Addendum No. 2 November 24,2026

Project: **EMS Training Pavilion**

GHS-D&C Project No: **F2026002**

Grady EMS Pavilion RFI 001

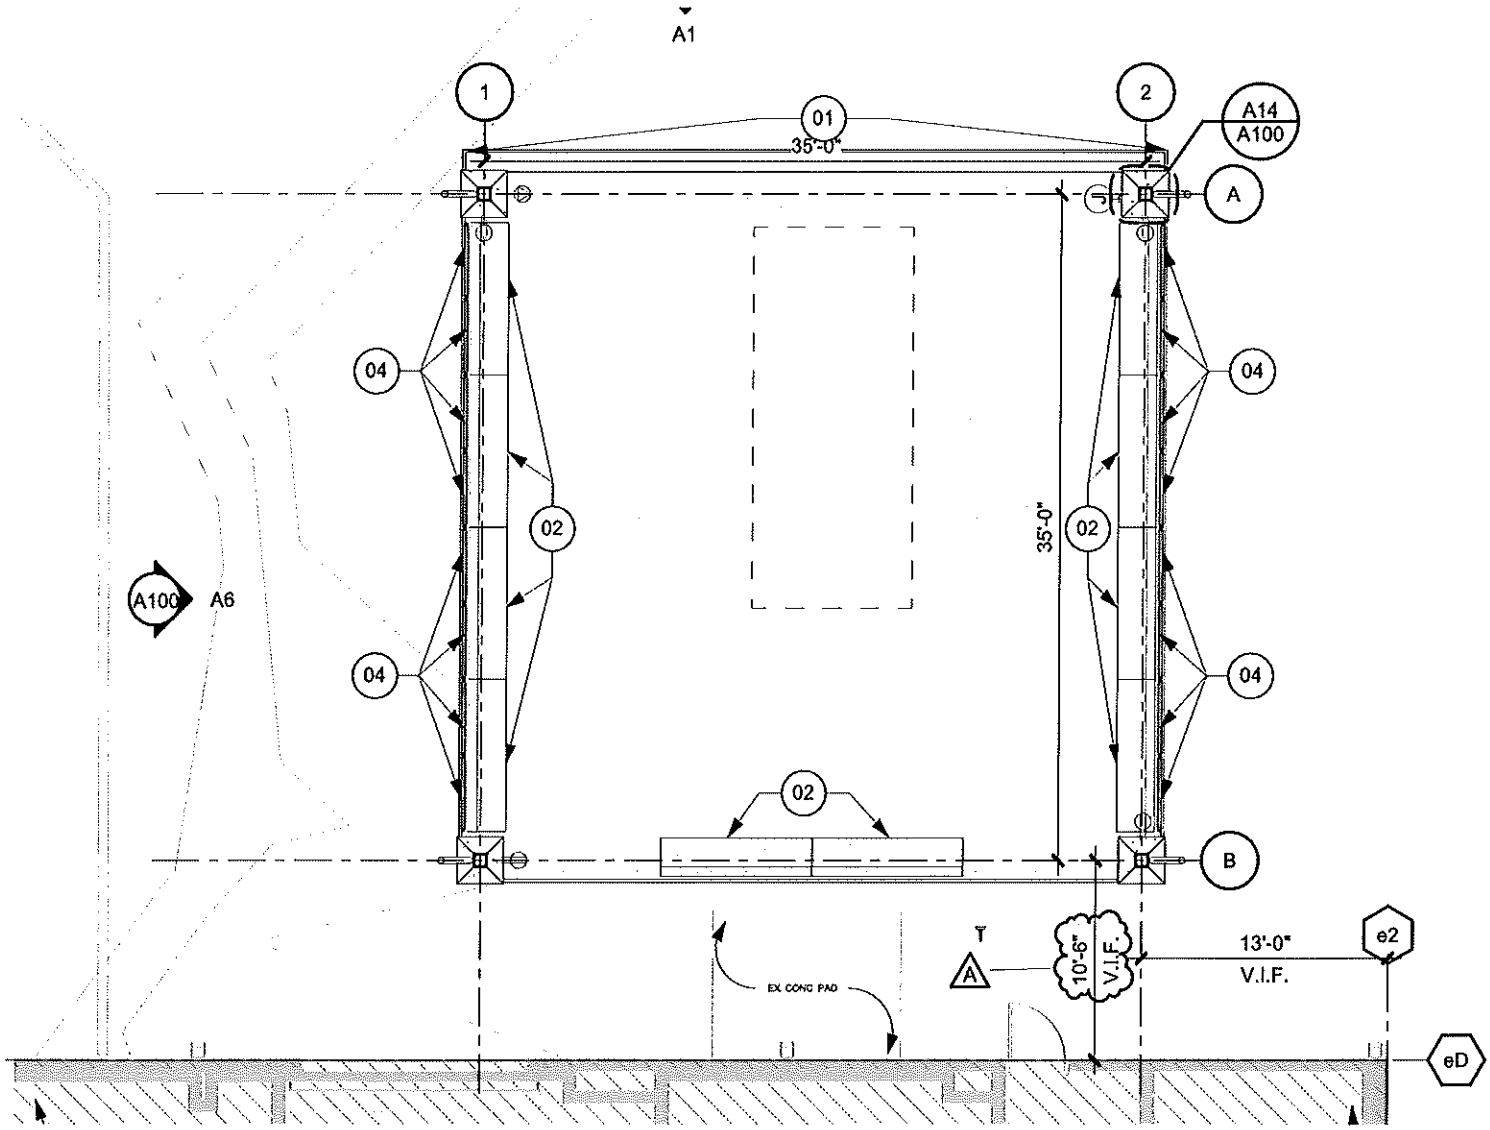
- Demo plan on C2.0 says to remove concrete pad, fence and disconnect for the three condensers but nothing is shown on mechanical plan and it's unclear whether to remove and reinstall the equipment or remove completely. Please provide clarification as CHC suggests moving the pavilion further away from the building to avoid conflicting with existing mechanical equipment. If necessary, we can always simply add sidewalk from the exterior door landing to the new pavilion.

SEE NEXT PAGE FOR PAVILION LOCATION - CDH
